SERVICE BULLETIN <small>SS-MAR0234</small>	model number 250	bulletin number M-250-3
	for serial numbers ABOVE 6549	
	subject POWER AMPLIFIER MODIFICATION PROCEDURE	
engineering approval 		date 8-16-76

This modification provides for increased amplifier reliability by the replacement of existing pre-driver, driver and output devices with improved versions and by the addition of flyback diodes to both channels of the amplifier.

C OUTPUT TRANSISTOR REPLACEMENT

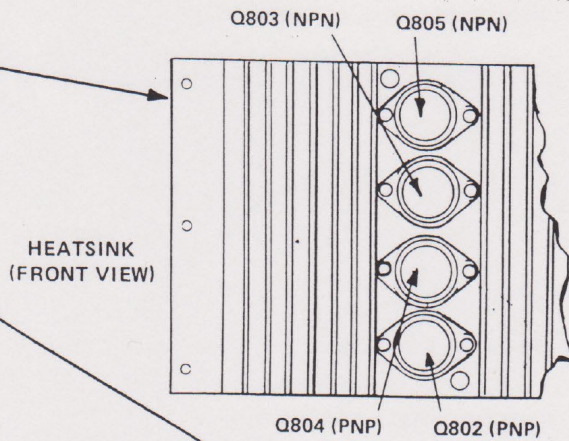
1. Position each heatsink as shown.
2. Remove the screws holding the top transistor on each heatsink.
3. Remove the old transistor and retain the mica insulator and hardware.
4. Select the correct replacement output transistor (NPN or PNP) and apply a thin layer of thermal compound to the transistor surface.
5. Add the mica insulator and apply thermal compound as necessary to the insulator.
6. Mount the transistor with mica insulator onto the heatsink using the hardware previously removed in step C-3.
7. Repeat steps C-2 through C-6 for each output transistor on both heatsinks.

Be absolutely sure that the NPN and PNP transistors are mounted in the correct locations.

AMPLIFIER BOARD (COMPONENT SIDE)

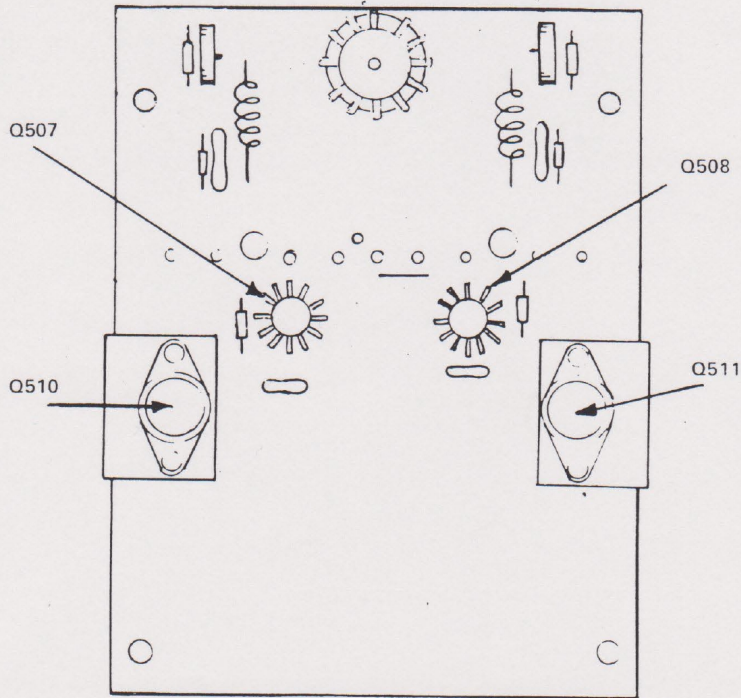
Using the Amplifier Board (component side) illustration for reference, remove each component listed in "REMOVE" columns one at a time, and replace with new components listed in the corresponding "Replace With" columns.

- NOTE:
1. Apply thermal compound to the surface of the driver transistors and mica insulators.
 2. Remove the heatsink from the old pre-driver transistor, apply thermal compound to the TO-5 case of the replacement pre-driver transistor and attach heatsink.

REMOVE			REPLACE WITH		
REF. DESIG.	PART NUMBER	DESCRIPTION	NEW REF. DESIG.	NEW PART NUMBER	DESCRIPTION
Q507	461-1056-000	Pre-Driver Transistor, PNP	same	461-2003-000	Pre-Driver Transistor, PNP, 2N5415
Q508	462-1068-000	Pre-Driver Transistor, NPN	same	462-2016-000	Pre-Driver Transistor, NPN, 2N3440
Q510	462-1054-000	Driver Transistor, NPN	same	462-2022-000	Driver Transistor, NPN, SJ6269 OR S42574
Q511	461-1046-000	Driver Transistor, PNP	same	461-2011-000	Driver Transistor, PNP, SJ6270 OR S42575

AMPLIFIER BOARD (FOIL SIDE)

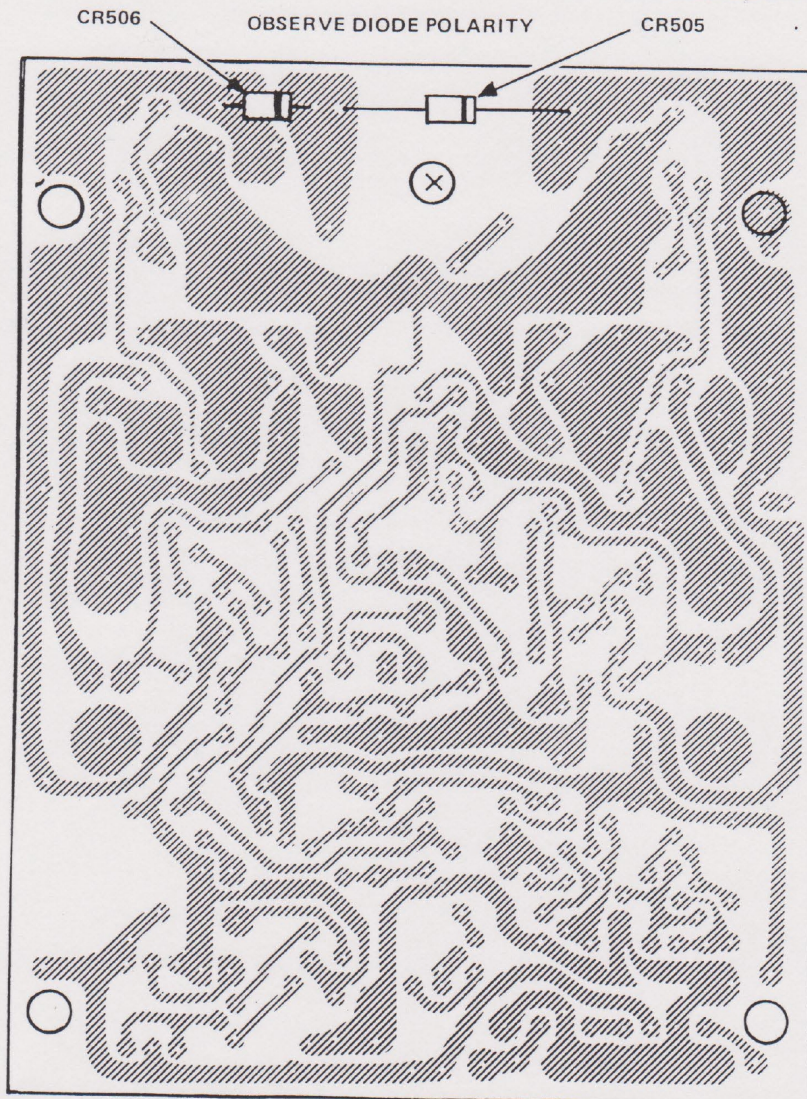
- E Using the Amplifier Board (foil side) illustration for reference, add the following new components to the foil side of each Amplifier Board.

REF. DESIG.	PART NUMBER	DESCRIPTION
CR505	460-2000-000	Diode, 1N4003
CR506	460-2000-000	Diode, 1N4003

MODEL 250 SCHEMATIC DIAGRAM (PARTIAL)
 (Modified per Marantz Service bulletin M-250-3)

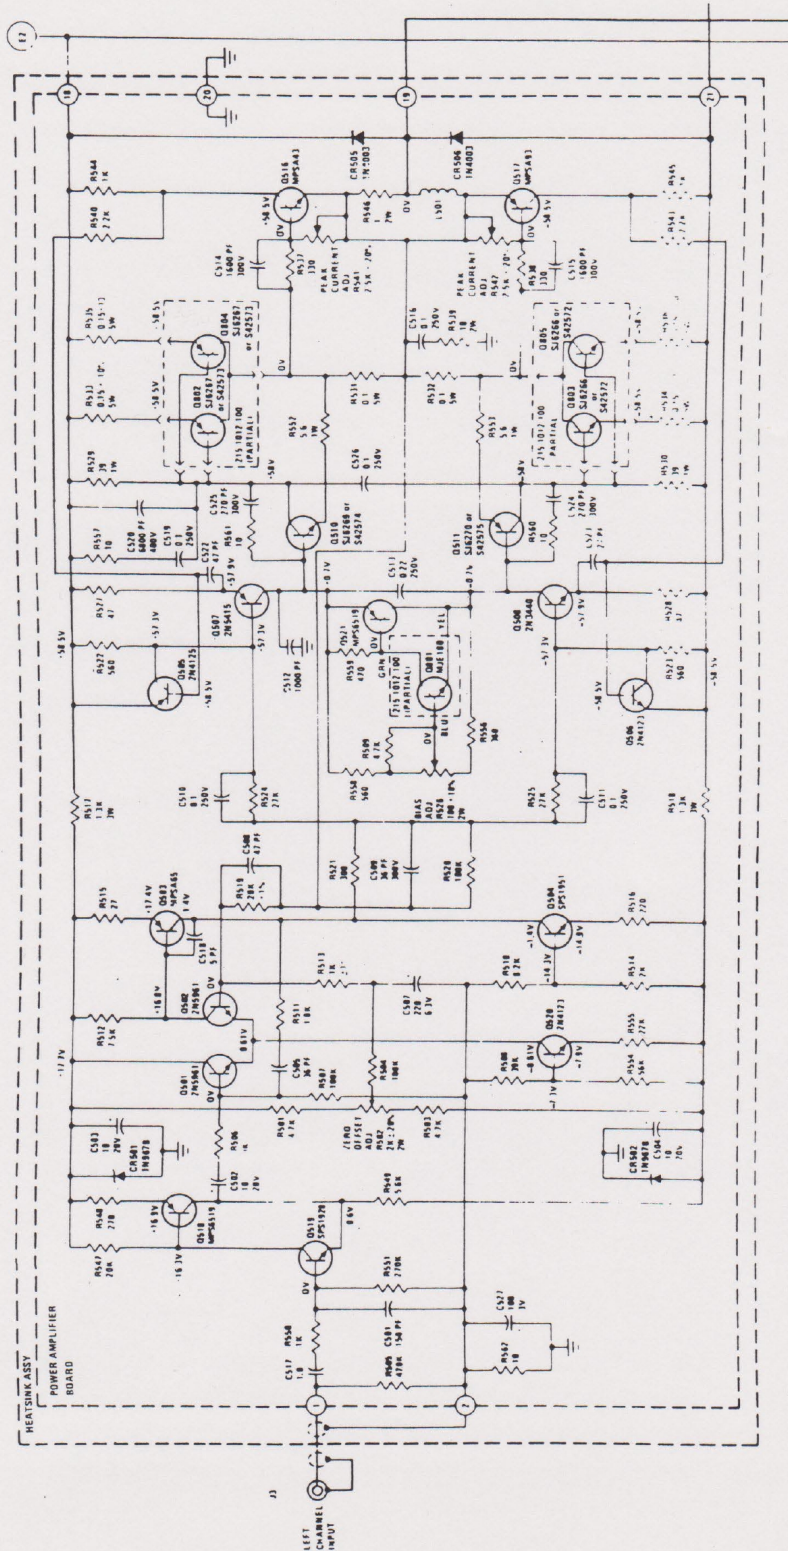
Substitute the following Bias Adjustment procedure for the Bias Adjustment Test shown in the service manual.

- a. Preset the bias adjustment potentiometer R526 on each amplifier board fully CCW.
- b. Connect a voltmeter across the series combination of R531 and R532 of the Left Channel, (voltmeter set to 0-100 mV range).
- c. Adjust the Left Channel bias adjustment potentiometer R526 for a voltmeter reading of between 24 and 30 mV.
- d. Repeat above procedure for Right Channel.
